CERTIFICATE OF APPROPRIATENESS

HPO File#: HP2025_0295

Property: 430 Woodland Street, Block 13, 1,812 sq. ft. single family residence, 5,000 sq. ft. lot
Woodland Heights

Proposal: Alteration:

Photo 7 – 2D Rending of Proposed Final Design:

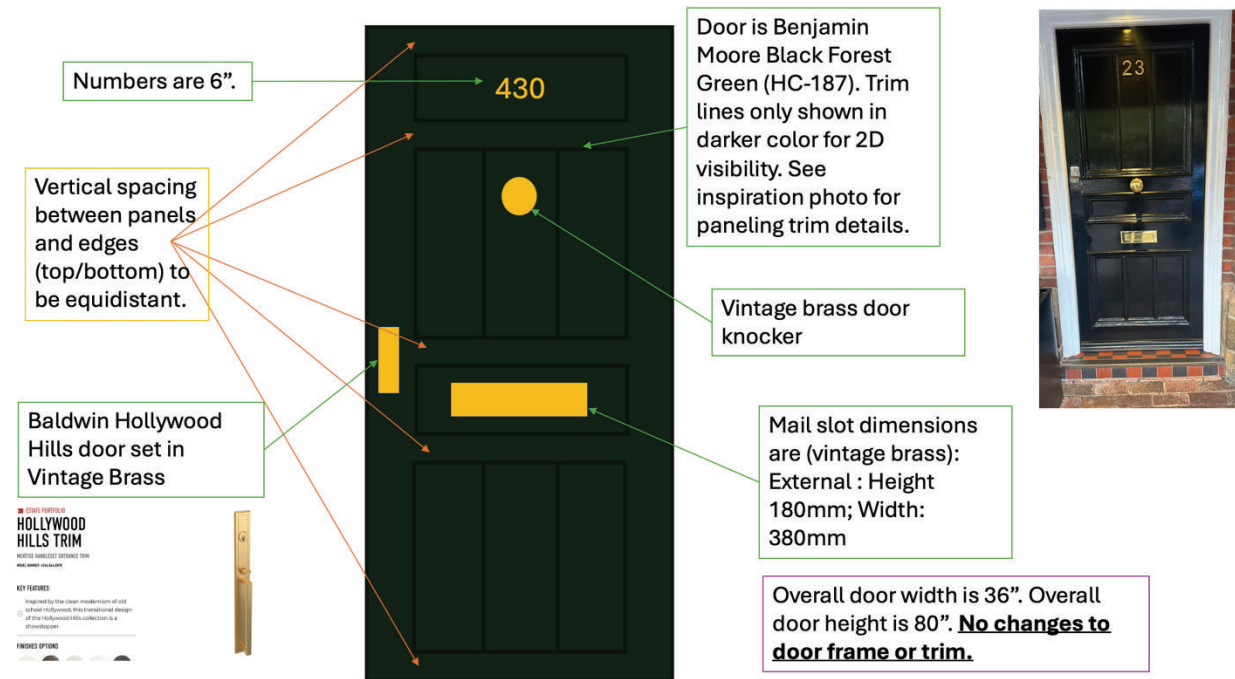
S	D	NA		S - satisfies	D - does not satisfy	NA - not applicable
☐	☒	☐	(1)	The proposed activity must retain and preserve the historical character of the property; <i>Proposed door is not in the Craftsman Style from which the home is.</i>		
☒	☐	☐	(2)	The proposed activity must contribute to the continued availability of the property for a contemporary use;		
☐	☒	☐	(3)	The proposed activity must recognize the building, structure, object or site as a product of its own time and avoid alterations that seek to create an earlier or later appearance; <i>Proposed door is inconsistent with Craftsman era of the home.</i>		
☐	☒	☐	(4)	The proposed activity must preserve the distinguishing qualities or character of the building, structure, object or site and its environment; <i>Removal of appropriate door.</i>		
☐	☒	☐	(5)	The proposed activity must maintain or replicate distinctive stylistic exterior features or examples of skilled craftsmanship that characterize the building, structure, object or site; <i>Proposed door does not match the Craftsman Style from which the home is.</i>

☐	☒	☐	(6)	New materials to be used for any exterior feature excluding what is visible from public alleys must be visually compatible with, but not necessarily the same as, the materials being replaced in form, design, texture, dimension and scale; <i>Proposed door does not match style of home.</i>		
☐	☒	☐	(7)	The proposed replacement of exterior features, if any, should be based on an accurate duplication of features, substantiated by available historical, physical or pictorial evidence, where that evidence is available, rather than on conjectural designs or the availability of different architectural elements from other structures; <i>Proposed door does not match style of home.</i>		
☐	☒	☐	(8)	Proposed additions or alterations must be done in a manner that, if removed in the future, would leave unimpaired the essential form and integrity of the building, structure, object or site; <i>Removal of appropriate door.</i>

☐	☒	☐	(9)	The proposed design for any exterior alterations or addition must not destroy significant historical, architectural, archaeological or cultural material, including but not limited to siding, windows, doors and porch elements; <i>Removal of appropriate door.</i>		
☐	☒	☐	(10)	The proposed alteration or addition must be compatible with the massing, size, scale material and character of the property and the context area; and <i>Proposed door does not match style of home.</i>		
☒	☐	☐	(11)	The distance from the property line to the front and side walls, porches, and exterior features of any proposed addition or alteration must be compatible with the distance to the property line of similar elements of existing contributing structures in the context area.
